Re: GCC Energy, LLC, King II Mine CDRMS Permit # C-1981-035

Stoner Engineering: Quarterly Inspection: Refuse Pile

3rd Quarter 2021

Re: King Coal I – Quarterly Waste Pile/Embankment Inspection

Pic. 2 – Erosion between haul road/NW corner of lower waste pile.

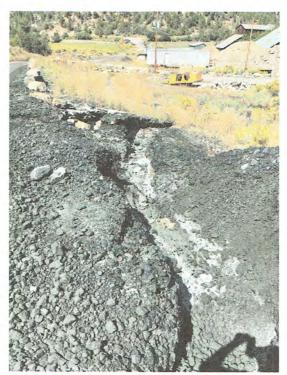
The south treated water ditch (Reach 10) and the south clear water ditch (Reach 1) appeared to be in generally good condition (see Pic. 1). There was some erosion from the recent storms at the northwest corner of the lower embankment pile along the east side of the haul road. If not addressed, this could result in excessive erosion, instability, sloughing or weakness (see Pic. 2). There was also erosion located at the southwest corner of the main waste embankment pile at the seam between the waste pile and the existing mountain (see Pic. 3). The erosion control measures at this location have been covered with sediment as a result of the erosion in this location. The erosion control measures should be re-established to prevent excessive erosion at this location.
